Director's Report

Project Name: 9101 Highland
 Description: Preliminary site plan approval recommendation & special land use approval
 Date on Agenda this packet pertains to: December 5, 2024

RE: 9101 Highland Road-Proposed Commercial Development- Preliminary Site Plan Review – 2nd Review

**Preliminary Site Plan / Special Land Use Review
for
White Lake Charter Township, Michigan**

SCALE: 1" = 30' PROJECT ID: DET-230219
 TITLE: LANDSCAPING PLAN
 DRAWING: C-8

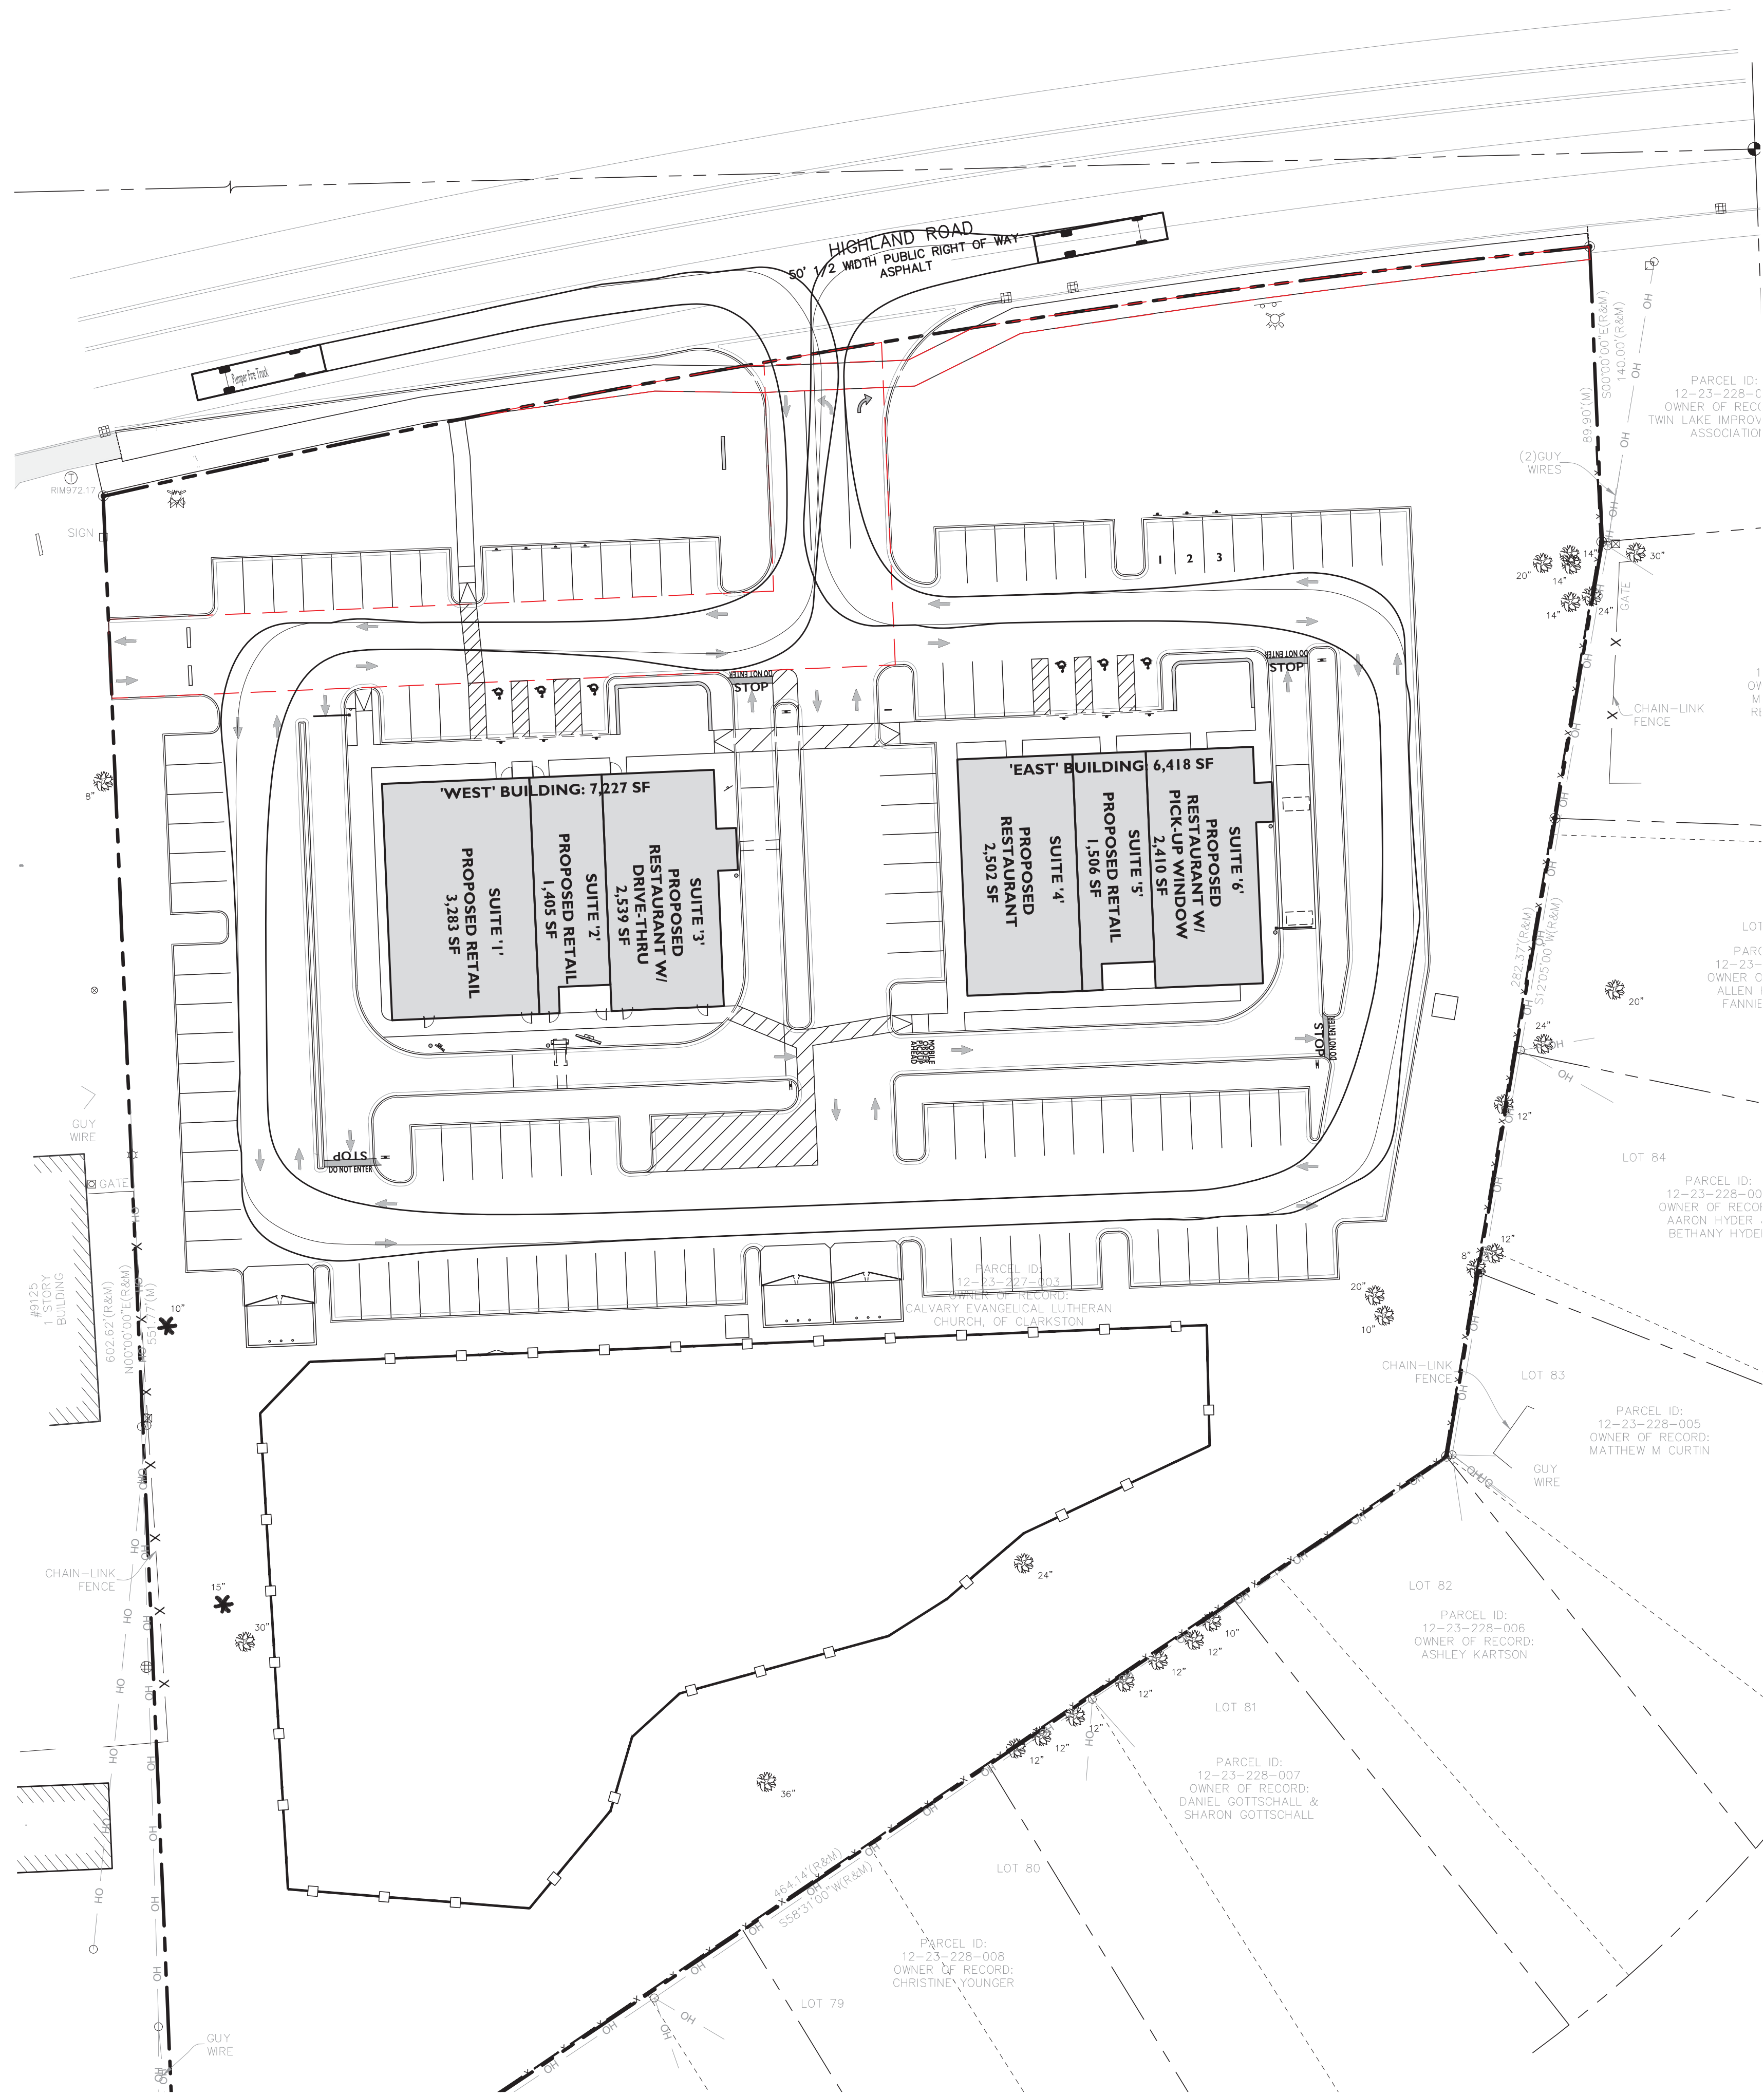
- aa) *Sheet C-8- Show proposed sanitary sewer, water service, and storm sewer. Please provide a minimum of 10' horizontal separation between trees and these utilities and add a note to this effect on this sheet. **Comment addressed. Utilities are now shown on plan sheet.***

- bb) *Sheet C-8- There is an existing tree that is shown to remain in the area of the proposed retention basin. Tree will likely be required to be removed, or basin location revised so as to avoid tree in basin. **Comment partially addressed. Existing tree within the basin shall be removed per the design engineer; however, please cross out this tree on Sheet C-2.***

Section 5.19.B outlines general provisions for site landscaping. We note that no trees are to be planted closer than four (4) feet from any property line. While distance dimensions were not provided, it appears several trees along the southern and eastern property line may encroach this setback requirement.

Items to be Addressed: 1.) Dimensions between trees and property lines should be included on Sheet C-8 and conform to the four (4) foot setback requirement. 2.) The applicant should remove the trash enclosure detail from Sheet C-13 and clarify the CMU enclosure wall decorative feature on Sheet A-302 for final site plan. 3.) Specification of screening materials proposed for the eight (8) foot property line fence are required for final site plan.
